**Subject: Response to Request for Information
Roseville College Sport and Wellbeing Centre (SSD-9912)**

I write in response to the Independent Planning Commission's (the Commission) request for information, dated 28 May 2021, in relation to the proposed Sport and Wellbeing Centre at Roseville College (SSD-9912).

Image 1: Acoustic barrier detail (Source: Applicant's Acoustic Assessment Report)

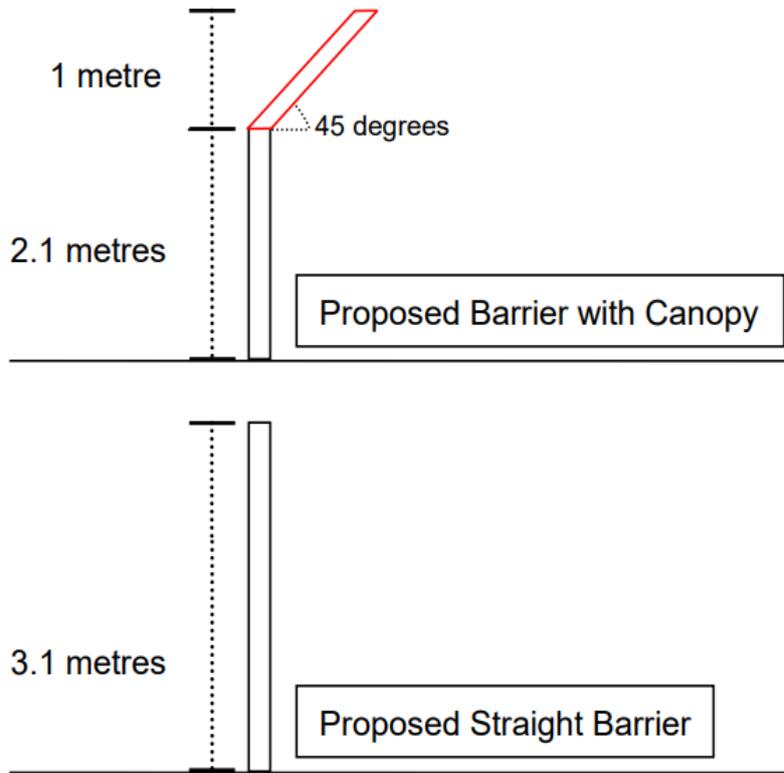
The Commission has requested a description of the proposed acoustic barrier located along the perimeter of the rooftop sports courts, including proposed materials and confirmation if the proposed acoustic barrier has been considered from a heritage perspective.

The AAR recommends an acoustic barrier comprised of a two metre high screen with a one metre high cantilevered canopy (or a three metre high screen) inside the perimeter of the rooftop sports courts. The materials are recommended to be comprised of either:

- a) a double layer Colorbond barrier; or
- b) masonry (brick or concrete); or
- c) a minimum nine millimetre thick compressed fibros-cement sheeting on timber or steel stud;
or
- d) other suitable material such as Perspex, modular walls or equivalent.

To further minimise the potential heritage impact of the acoustic barrier and to ensure that the structure is acceptable from a heritage perspective, the Department recommends the inclusion of a condition of consent requiring a minimum of one metre of the top of the acoustic barrier to comprise of an appropriate transparent material similar to that shown in Image 2 at **Attachment B** (straight barrier) and the bottom to be comprised of a recessive colour
